Subject: Transmit Electric Power Research Institute NEI 03-08 Interim Guidance MRP 2021-005
Related to B&W-Designed Core Barrels to NRC for Information

Subject: NEI “Needed” Interim Guidance regarding MRP-227-A and MRP-227, Revision 1-A B&W Core Barrel Cylinder Top Flange Circumferential Weld Heat-Affected Zone Inspection

**CUSTOMER SERVICE BULLETIN NO. 21-04**

SUBJECT: Post Stress Relief Weld Repairs in the B&W Core Barrel and Impact on SCC Susceptibility

Figure 1: Location of CB Cylinder Top Flange Circumferential Weld – B&W-Designed PWRs

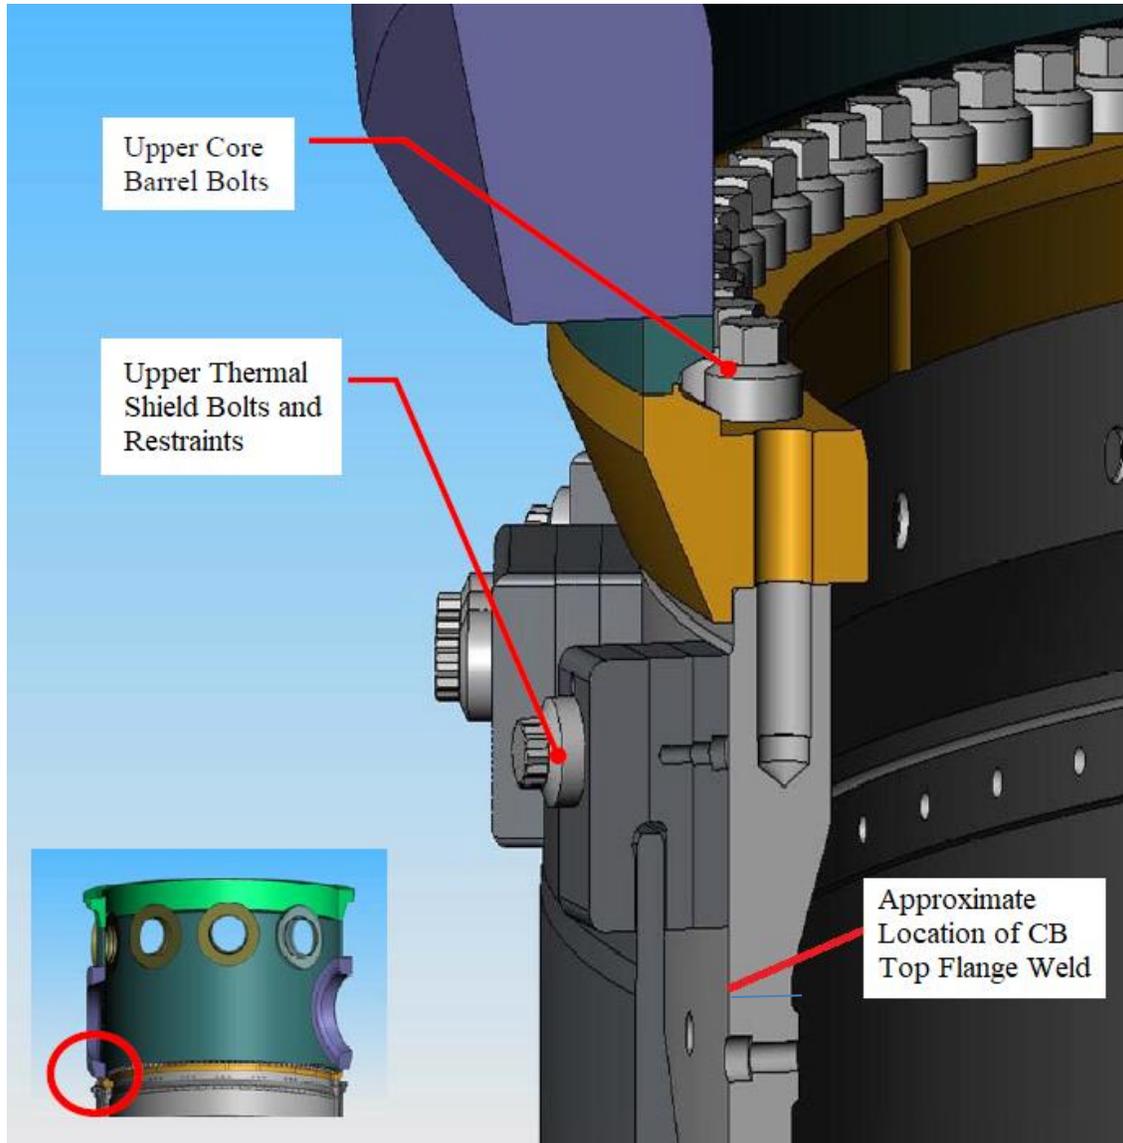
The CB cylinder top flange circumferential weld HAZ shall be the Primary item for SCC for units that had weld repairs performed on their top flange circumferential weld after the stress relief. There are no associated Expansion items.

Primary Item: CB cylinder top flange circumferential weld HAZ; see Figure 1

Effect (Mechanism): Cracking (SCC, IE), including detection of surface-breaking crack-like indications

Examination Method: Enhanced visual (EVT-1), volumetric (UT), or eddy current (ECT) examination

Initial Inspection: At the time of the next planned RV internals removal (i.e., coinciding with the next 10-year in-service inspection [ISI] of the RV internals)

Examination Coverage: 100% of the accessible outer diameter (OD) surfaces of ¾” of the adjacent base metal to the top flange circumferential weld, as defined in MRP-228 [Reference 5]. Examination coverage requires a minimum of 50% of the length of the specified surface of the weld being examined due to the potential obstruction of the upper thermal shield restraints at the top of the core barrel cylinder.

Examination Acceptance Criteria: The absence of a relevant condition (i.e., the specific relevant condition is a detectable crack-like surface indication)
